**Comments of Powerex Corp. on
Imbalance Conformance Enhancements**

Submitted by	Company	Date Submitted
Mike Benn 604.891.6074	Powerex Corp.	December 20, 2017

Powerex appreciates the opportunity to provide comments on the CAISO’s November 29, 2017 Imbalance Conformance Enhancements Issue Paper & Straw Proposal. In its proposal, CAISO explains that the purpose of this proceeding is to clarify CAISO’s authority to make manual adjustments to load forecasts in the integrated forward market and the real-time markets (commonly referred to as “load biasing”).¹

Figure 1.7 Average 3rd quarter hourly load adjustment (2016 – 2017)

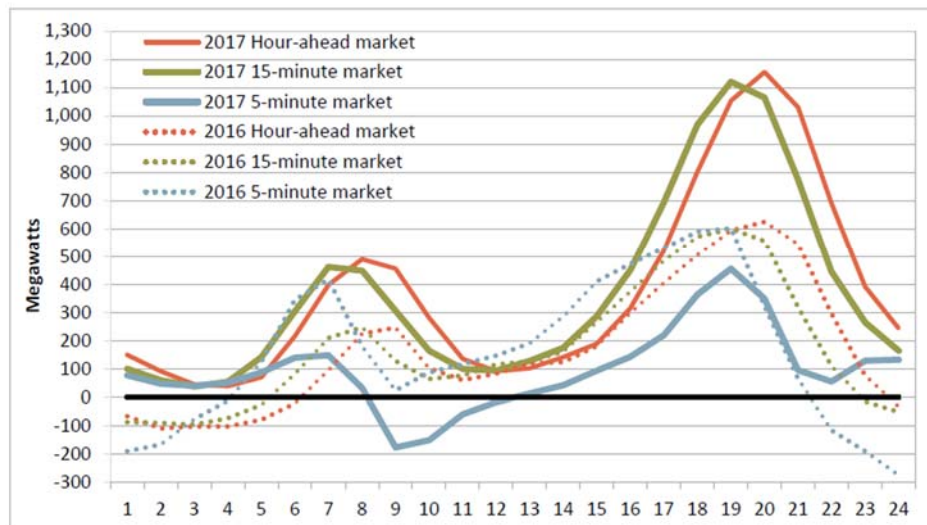
This figure shows that the load biasing in the CAISO BAA exceeds 1,000 MW *on average* during the evening peak, and is close to 500 MW *on average* during the morning ramp. Moreover, the figure shows that the quantity of load biasing during these hours is approximately twice as large as during the same quarter in 2016. Finally, the figure shows that load biasing in the 5-minute market—while less severe than in the 15-minute and hourly market process—exhibits strong and persistent patterns across the day.

The inescapable conclusion is that the use of load biasing in the CAISO BAA is not limited to correcting for random and unpredictable errors. Rather, load biasing in the CAISO BAA has become a mainstay of market operations, and appears to be used to compensate for persistent inaccuracies in the information regarding grid conditions and/or resource capabilities and expected performance.

Powerex reiterates that, given inaccurate information, grid operators can and should enter manual load adjustments in an effort to bring the market solution closer to the actual imbalance energy needs of the grid. However, regular use of load biasing should be recognized as potentially masking market design or information issues. The root causes of these issues need to be identified and addressed. In particular, CAISO needs to examine and explain:

- Why it is that operators need to regularly apply large, positive load biases during the morning load ramp hours and during the evening peak net load ramp hours, apparently day after day?

- Why has the amount of load bias grown so significantly in the past year?
- Why do these load biases occur primarily in the hourly and 15-minute market runs, with far smaller load bias in the 5-minute market?

Ramp-limited supply is 250 MW in all scenarios

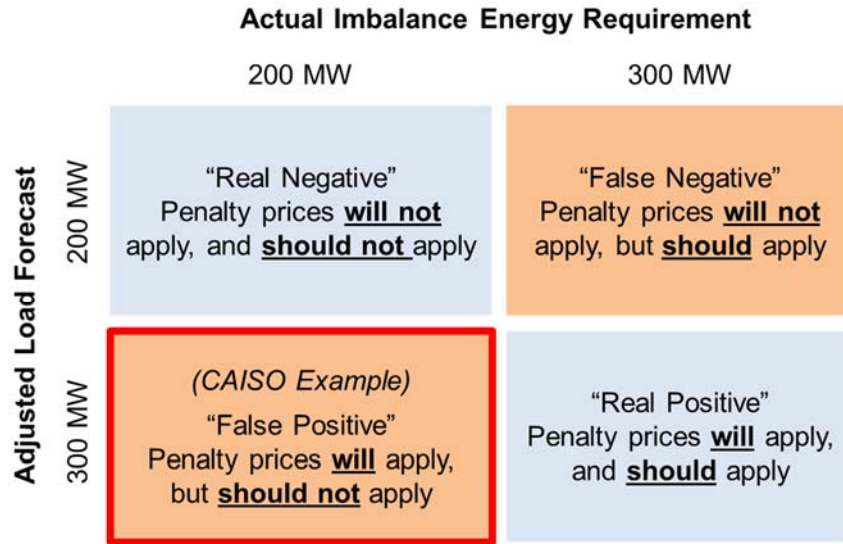
The illustration above highlights two important points. First, the load bias limiter addresses only one of the two erroneous outcomes that may arise when operators manually adjust load forecasts. That is, it attempts to address “false positive” outcomes, where the adjusted forecast overstates actual imbalance energy requirements, and hence penalty prices will apply when in fact they should not. The load bias limiter does nothing to address the other erroneous outcome: when the adjusted forecast understates actual imbalance energy requirements, and hence fails to trigger penalty prices when they should, in fact, apply. This asymmetry of the load bias limiter—which attempts to address “False Positives” while not addressing “False Negatives—will have the intended effect of avoiding penalty prices when they should not apply, but without also ensuring they are triggered when they should apply. This will result in an overall suppression of price volatility and price levels.

Second, the illustration also shows that there are “real positive” outcomes in which penalty prices *should* apply, because ramp-limited supply *is actually insufficient* to meet the system need for imbalance energy. If the load bias limiter prevents penalty prices from applying in these instances, **it will be creating pricing errors rather than preventing them**. Critically, however, neither the current load bias limiter nor the proposed new load bias limiter design includes a mechanism that distinguishes between conditions of “false” as opposed to “real” scarcity. While the entire premise of the load bias limiter is to avoid “spurious” prices due to “artificial” scarcity, nothing in the design of the load bias limiter establishes whether the scarcity conditions are, indeed, “artificial” as opposed to genuine. Without the ability to distinguish between “artificial” and genuine scarcity, the load bias limiter is fatally defective.
